COLORADO SPRINGS UTILITIES  
2021 NE GRAVEL STAGING AREA RELOCATION

SITE DEVELOPMENT PLAN

PCD File No. U-21-001 and PPR-21-050  
Colorado Springs Utilities NE Gravel Staging Area  
Site Development Plan Checklist

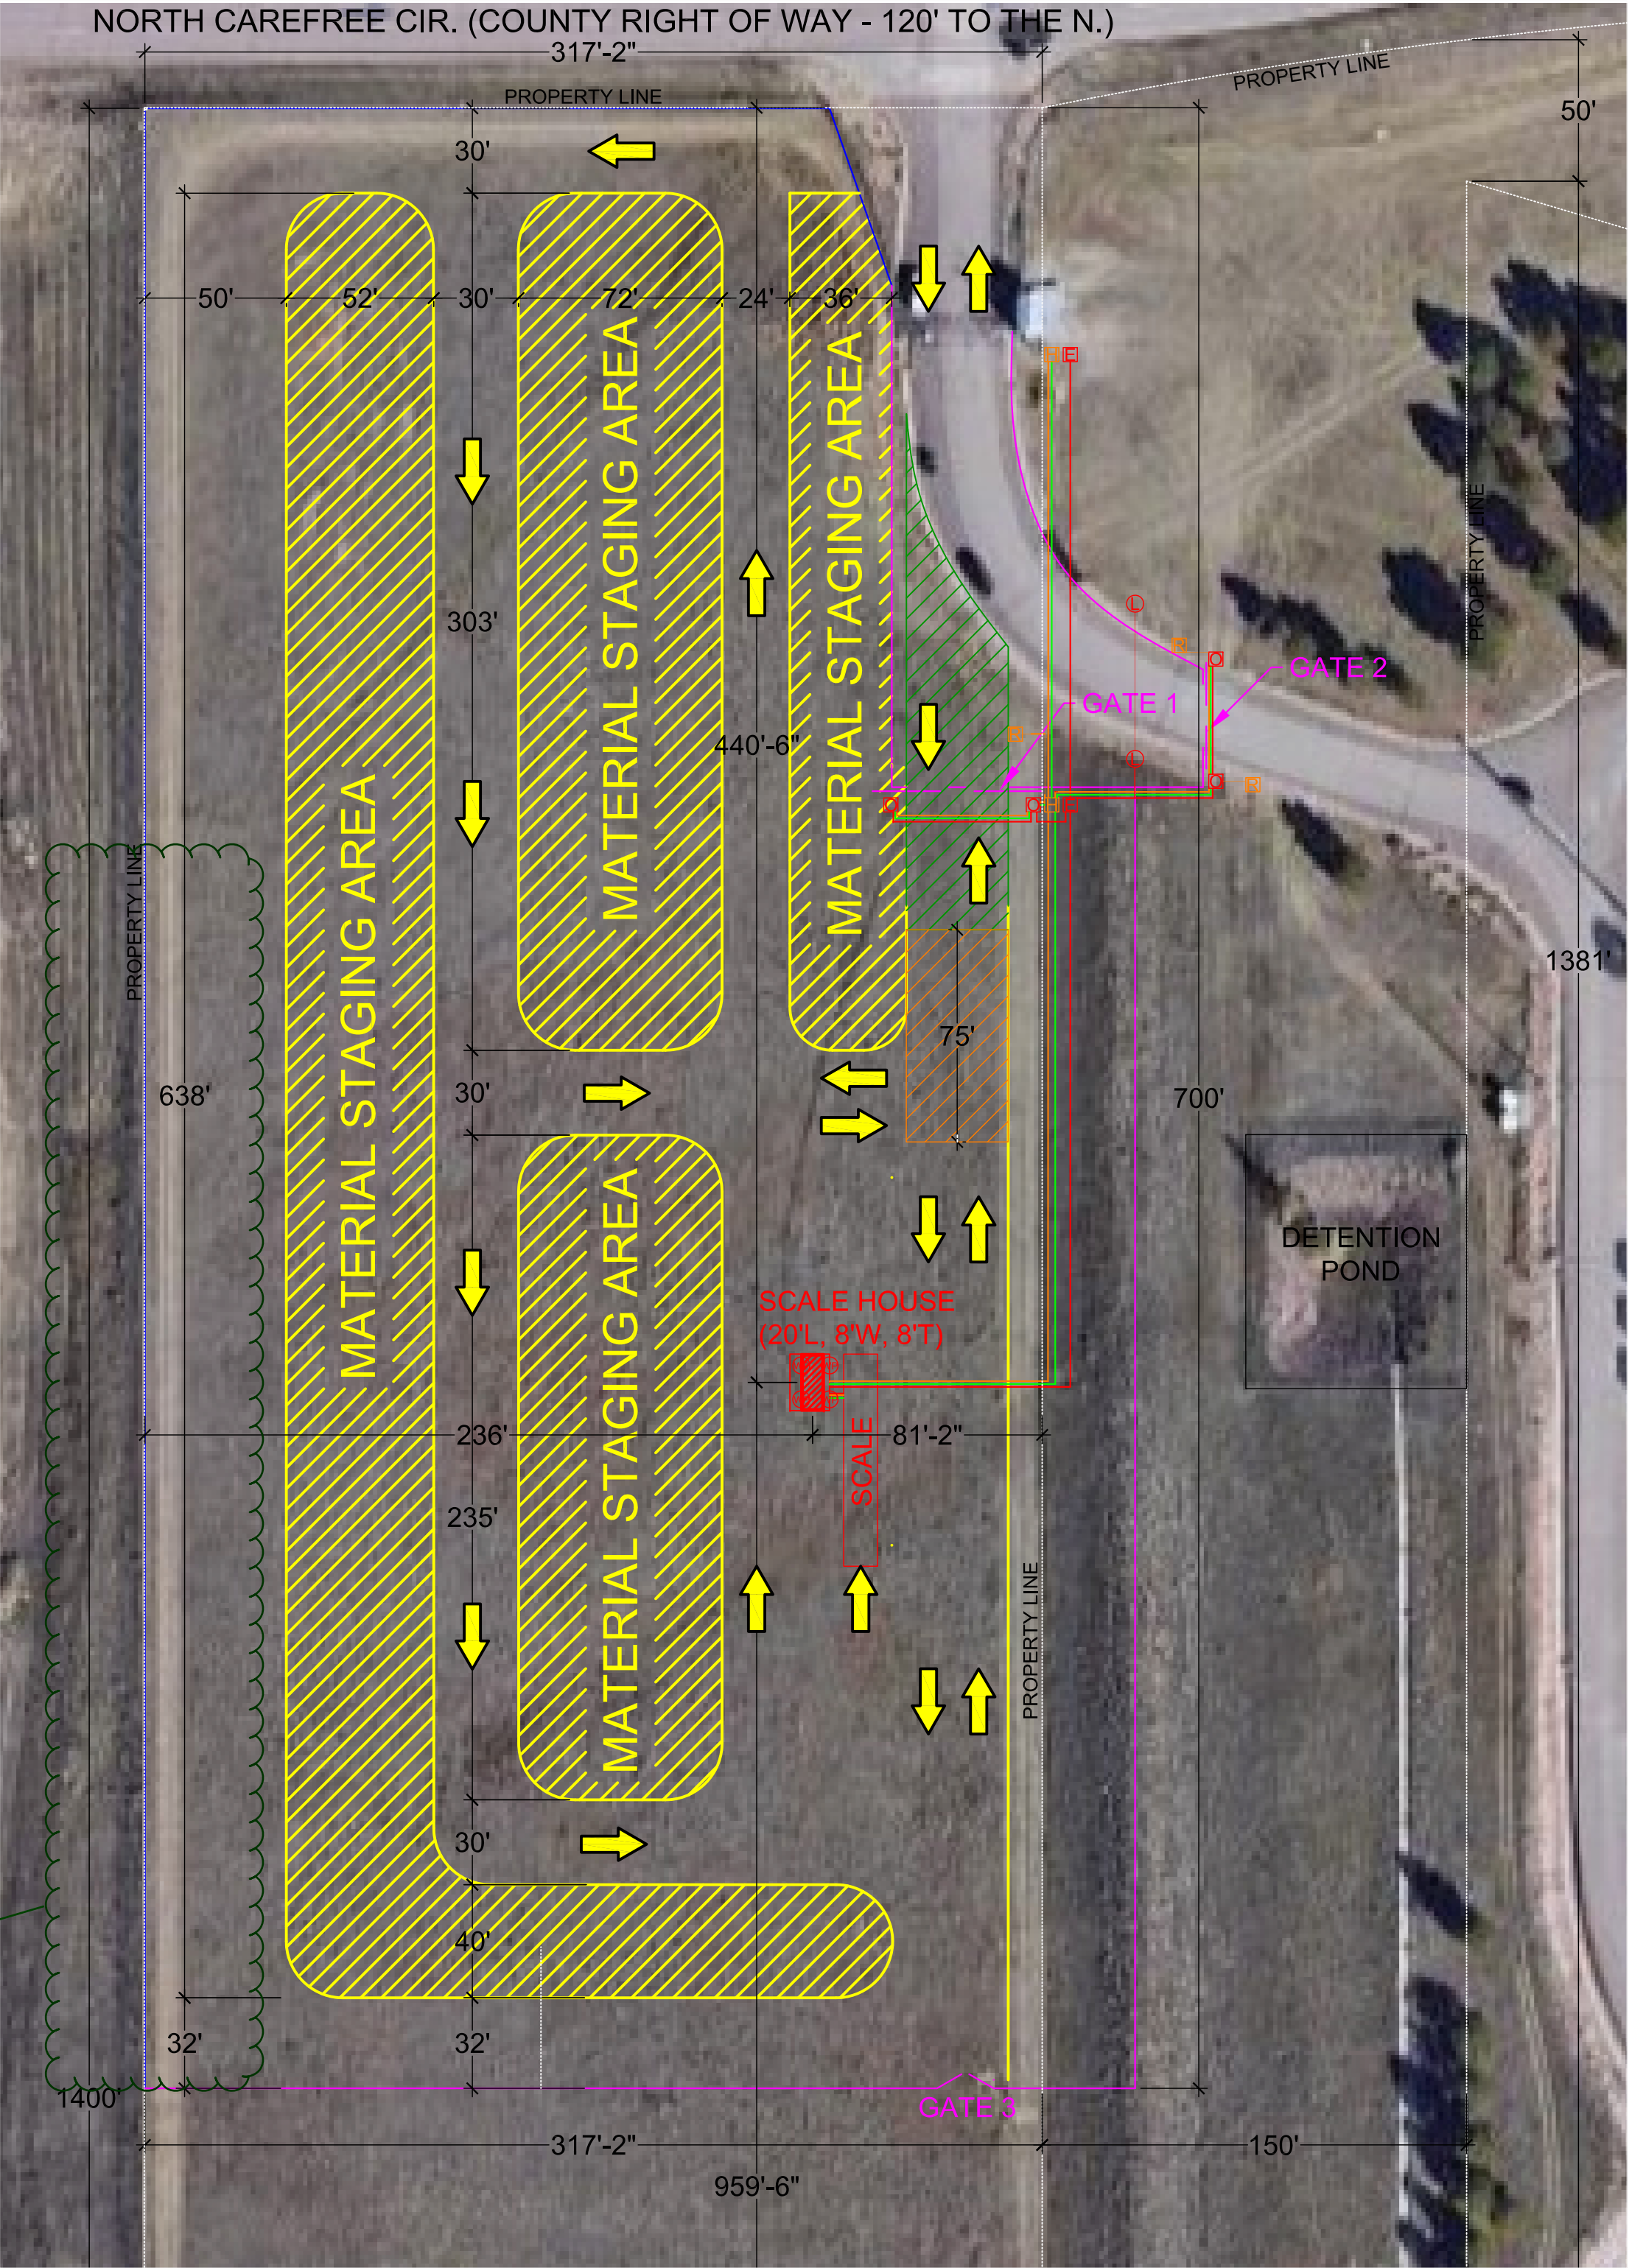
This site plan still does not depict the proposed 7 ft tall fence
